**RE: CONSTRUCTION OF 21 WIND TURBINES AND ANCILLARY WORKS AT  
CASTLEBANNY, CO. KILKENNY.  
SID: *Springfield Renewals Limited [Applicant]***

Planning Authority report in accordance with the requirements of  
Section 37E(4) of the Planning and Development Act 2000 (as amended)

<b>An Bord Pleanála Ref. No.:</b>	<b>309306</b>
<b>Applicant:</b>	Springfield Renewables Limited
<b>Agents:</b>	Tobin Consulting Engineers
<b>Site location:</b>	<p>The proposed wind farm is located between the settlements of Mullinavat, Inistioge and Ballyhale, which are located approximately 4.1km southwest, 5.7km northeast and 1.9km northwest of the site of the proposed wind farm respectively and within the townlands of Castlecoster, Derrynahinch, Kiltorcan, Coolroe Beg, Baunskeha, Castlebanny, Kilvinoge, Cappagh, Coolnahau, Ballytarsna, Mullennakill, Glenpipe, Ballymartin, Ballyvatheen, Ballynoony West, Derrylackey, Garrandarragh, Ballygegan and Ballyvol Co. Kilkenny</p> <p>The site incorporates an area of approximately 1,434 hectares (ha). The boundary of the main wind farm site (which excludes the grid connection, the offsite forestry replanting lands and the temporary public road upgrade works associ

Images for VP10 from photomontages are show below for illustration

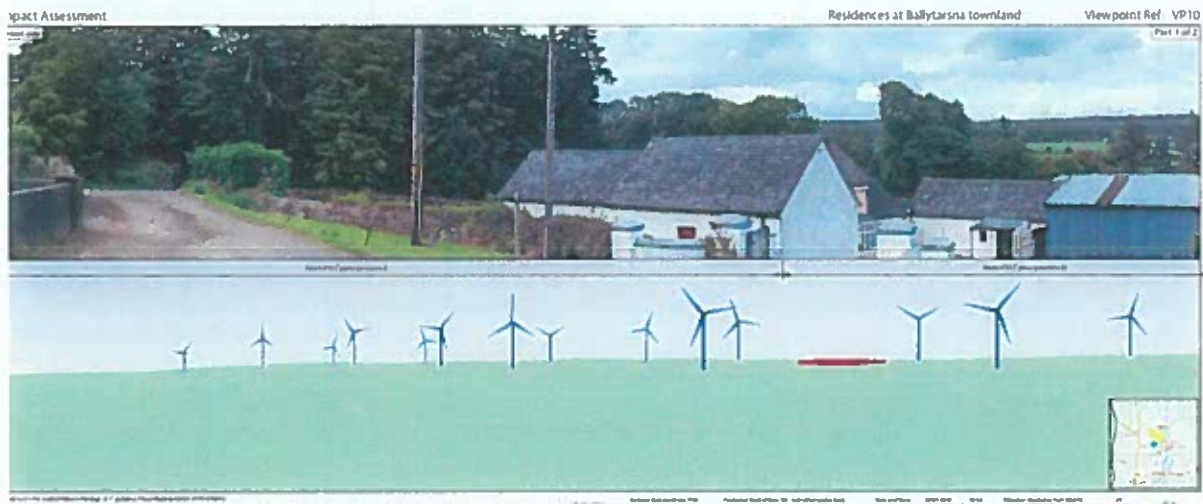
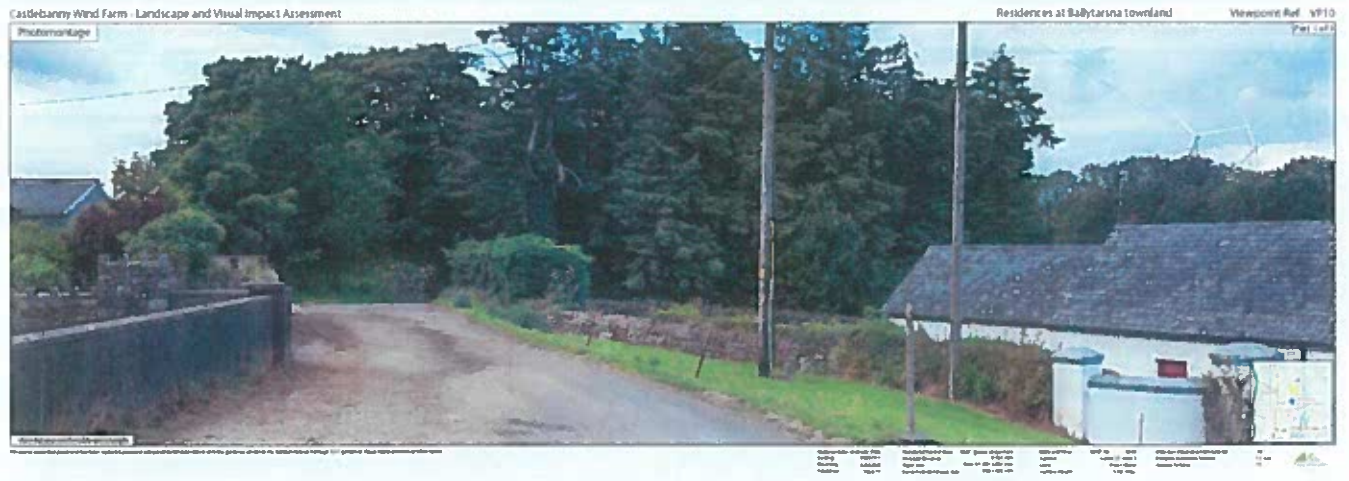
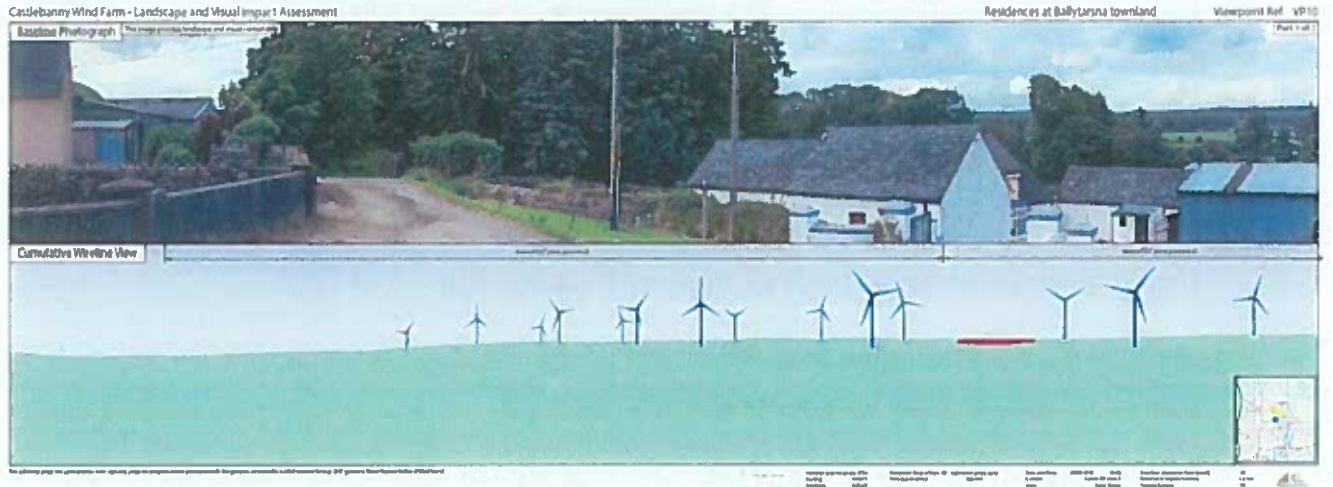
Similarly to VP10 the Council would consider the impact from this view point to be significant. It is noteworthy that at this view point there is an existing dwelling and it is clear from the images that the full impact on the dwelling has not been shown.

The Council considers that the proposed layout requires to be reviewed and revised according to a more realistic impact analysis which would require

### Chapter 15 Cultural Heritage

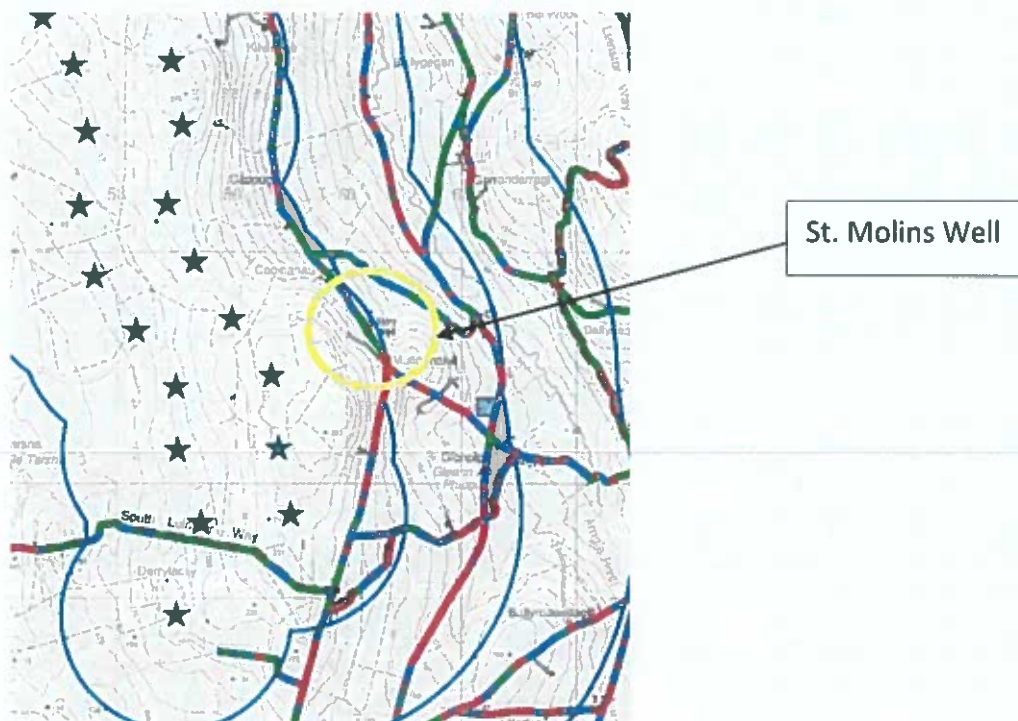
A particular aspect of the cultural heritage analysis which the Council considers is weak is the impact of the proposed development on St Molin’s well.

The Council would consider that given the proximity of the site to the development and the clear views from the Holy Well across the river valley that the potential impact here needs to be examined in more detail and mitigation measures to be introduced.
